Product change notification (PCN)

Title / short description	New plastic tool
Affected article category	Electronic housing
Change category	Form and appearance
Change number	PAC190023-03

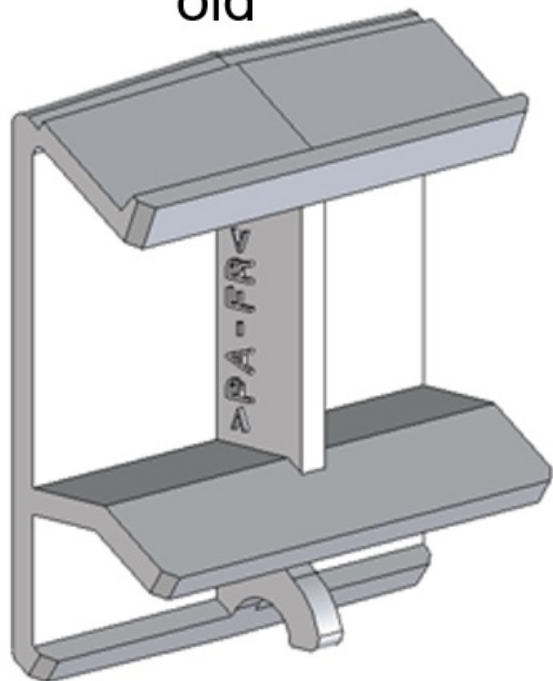
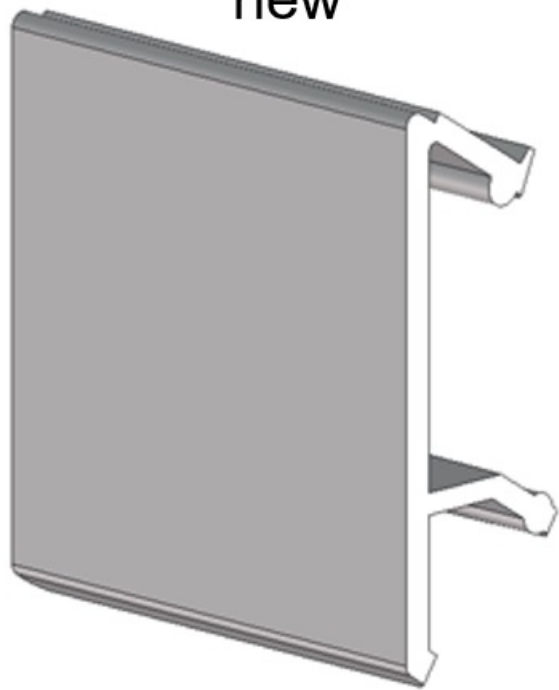
The previous plastic tool has reached the end of its service life and must be replaced by a new tool. As part of this, a product improvement will be introduced in the form of optimized radii. In addition, the text applied will change from "PA 66-FR" to "PA-FR" and a nest designation will be added. This does not affect the component's function.
